Review of Investigation Report on the Flooding in
Sha Po Tsai Village, Tai Po on 22 July 2010

Professor Joseph Hun-wei Lee
Croucher Laboratory of Environmental Hydraulics
The University of Hong Kong

12 October 2010

Figure B1 Velocity field at Stream A and Stream B

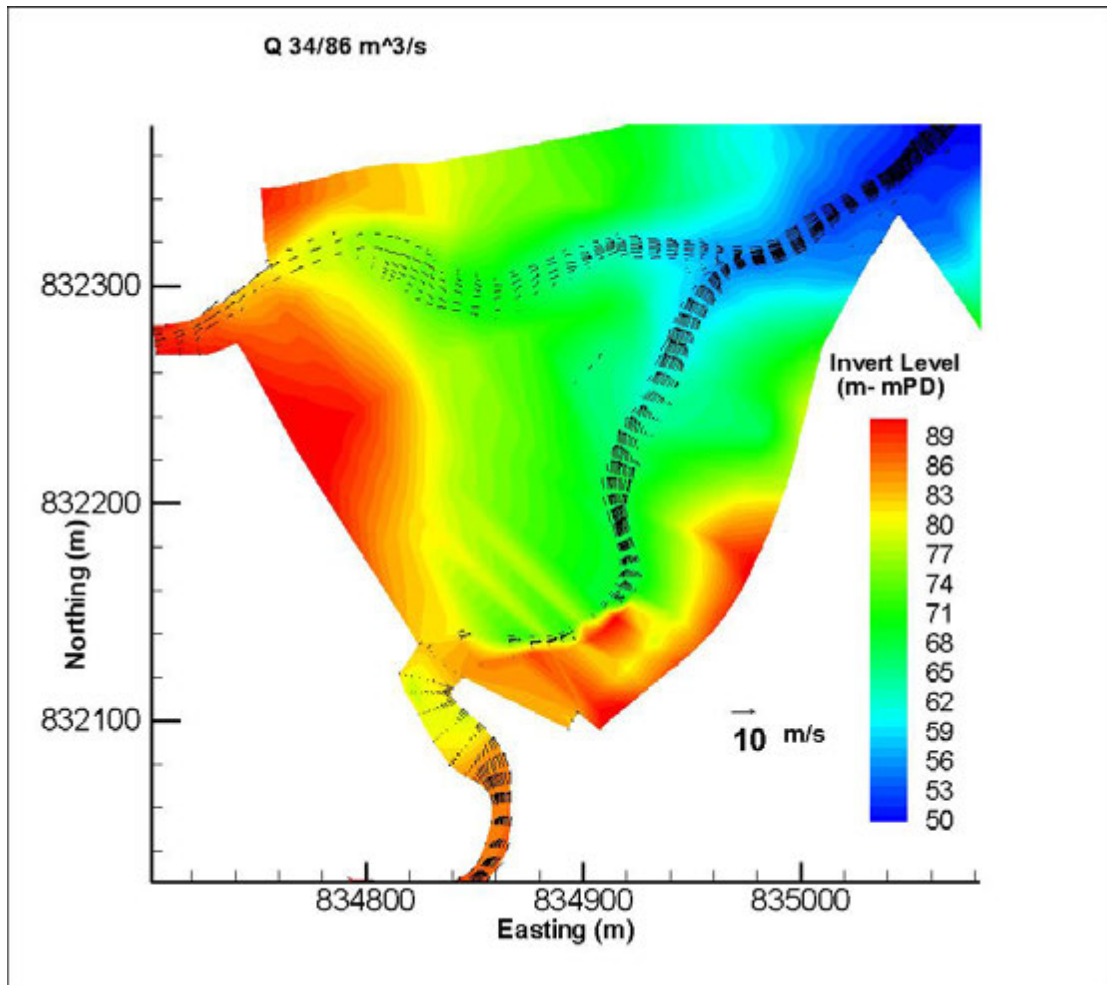
- The pattern of computed velocities on the steep streams and after the confluence (Fig. B1-B3) is consistent with the field observations.

In the absence of detailed water level data, it is difficult to estimate the discharge from the air-regulated siphon. However, based on the velocities required to generate significant scour (Fig.B1), it was probable that while the vortex intake protected downstream flooding by intercepting part of the runoff as designed, a discharge of 20-30 m³/s might have occurred.

Figure B4 Predicted flow downstream of boulder trap - with and without gabion wall

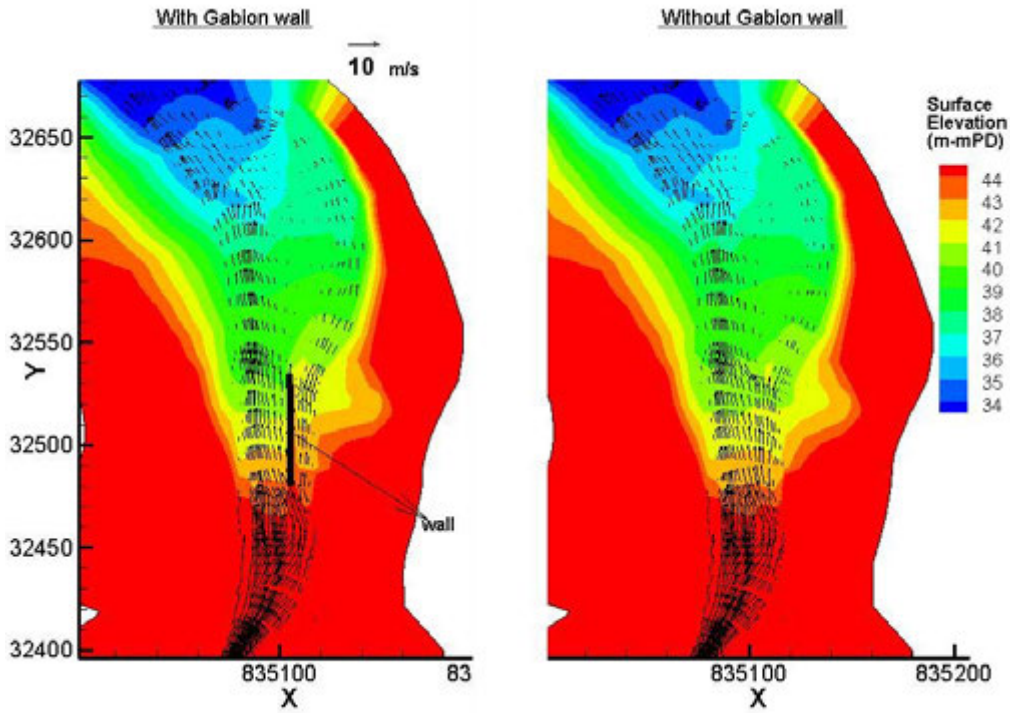
in significant scour of a loosely compacted bed downstream of the boulder trap (Fig.B4).

The 60 m long gabion wall downstream of the boulder trap did not affect the flow through the east branch which seems to be chiefly governed by the topography and flow capacity (Fig.B4 and Fig.C1, C2).

Figure B10 Predicted water surface elevation along central and west branches (pre-project)

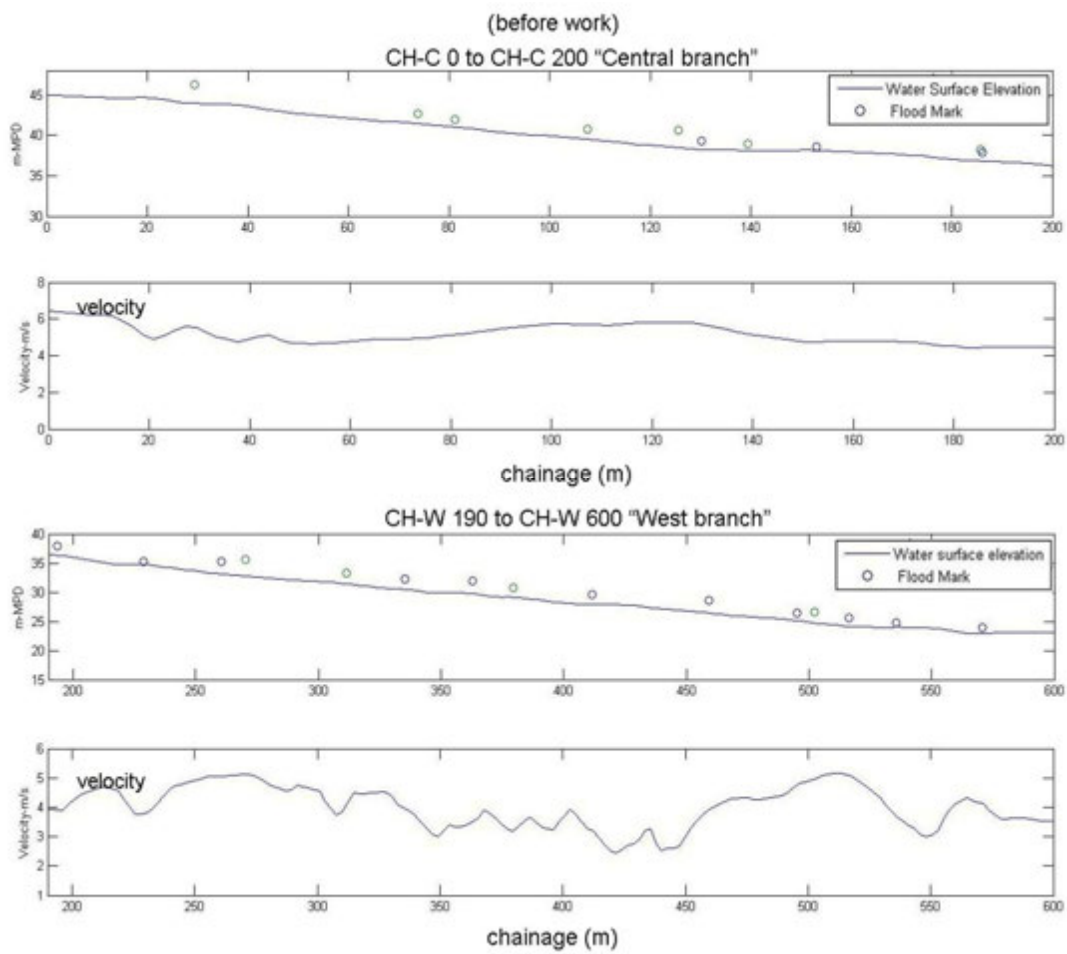
- In the absence of all engineering works, both 2D and 3D model calculations show that flooding would still have occurred (Fig.B10, see also Appendix C).

Figure C3 Computed surface velocity field near check dam (CH 140 – 300)

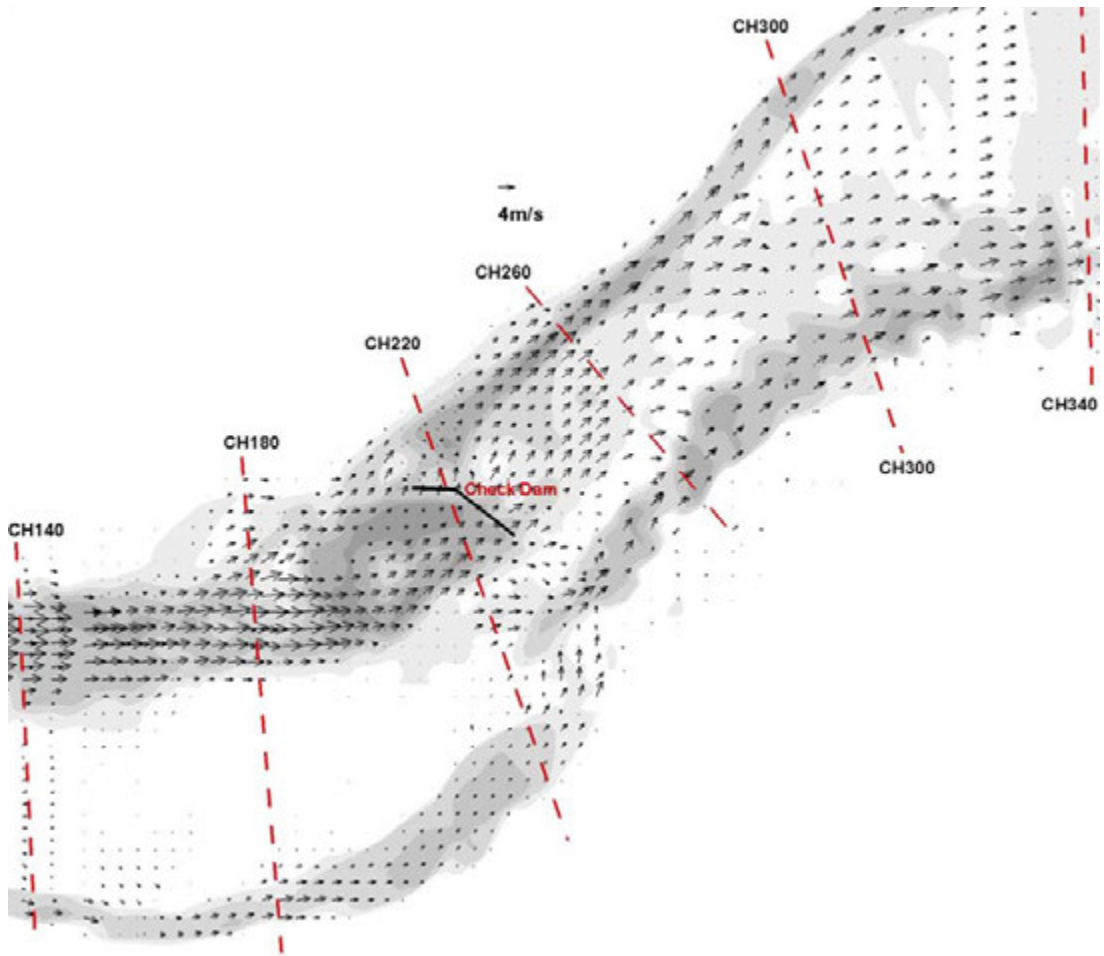
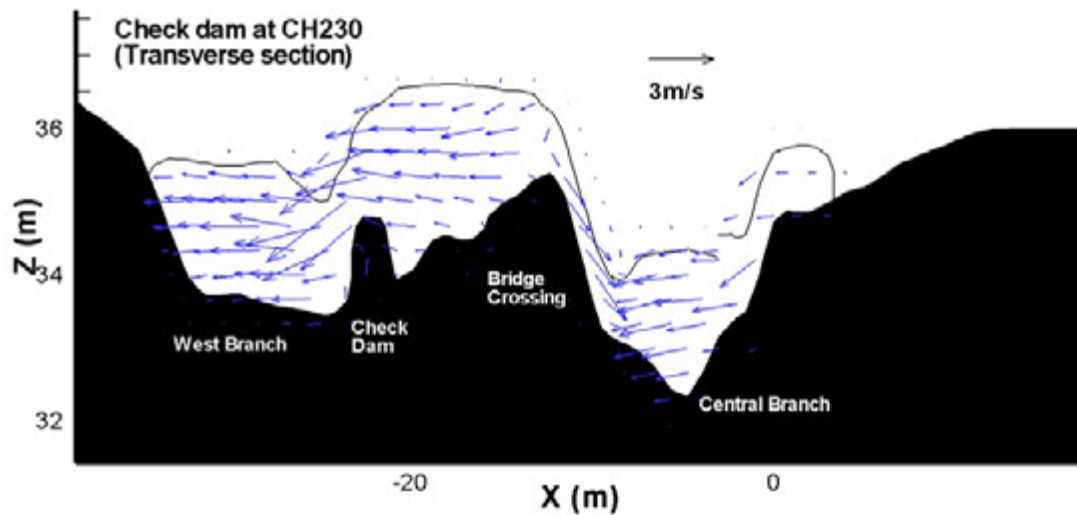
The presence of the check dam and gabion wall near CH230 did not aggravate the flooding situation in terms of maximum flood level and velocity in the Sha Po Tsai vicinity. The flood flow impinging on the pre-existing flood wall and the head of the island would result

in a pile up of water and subsequent flooding; this would be further aggravated by any coarse sediment that would block the bridge crossings to some extent (Fig.C3, C4 and C5).

Fig.C6 Predicted water level along main (central) branch of Tai Po River

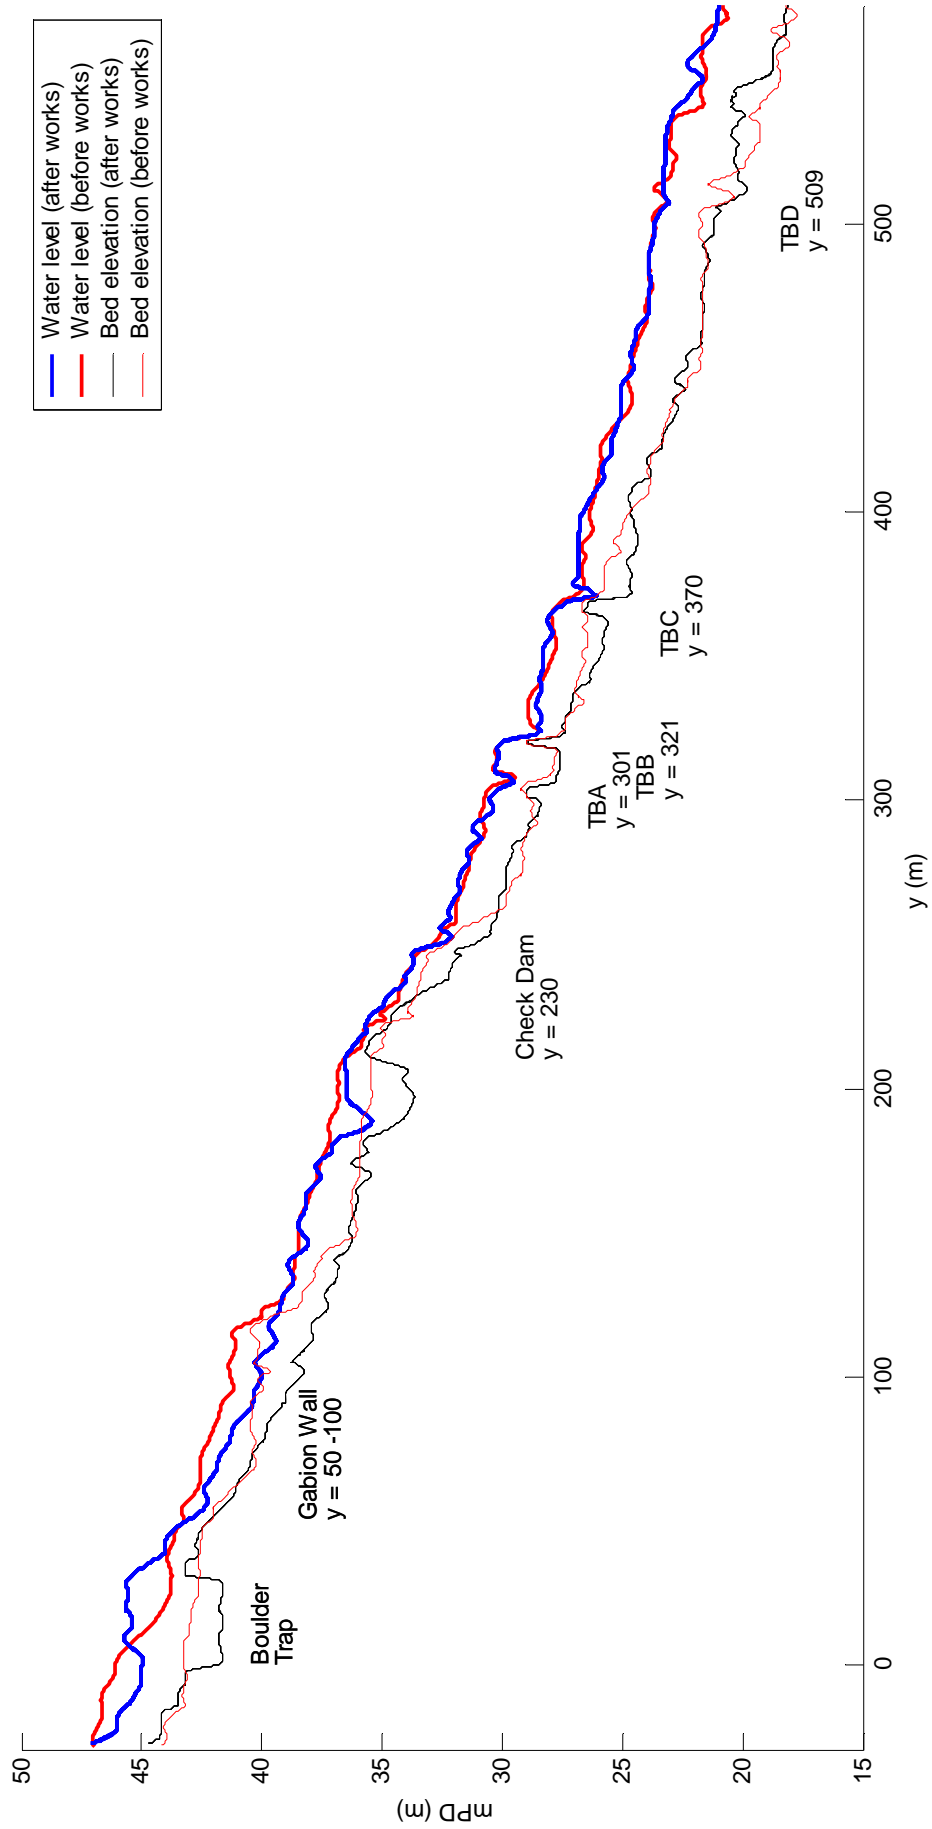
The results show that even in its natural state, the Tai Po River would have flooded to similar levels when subjected to this flood flow (Fig.C6). Compared to the pre-project situation, the completed works have resulted in some minor decrease in flood level and velocity in some locations but increase in other locations. Overall, it is judged that the difference in flood risk due to the constructed works is acceptable.
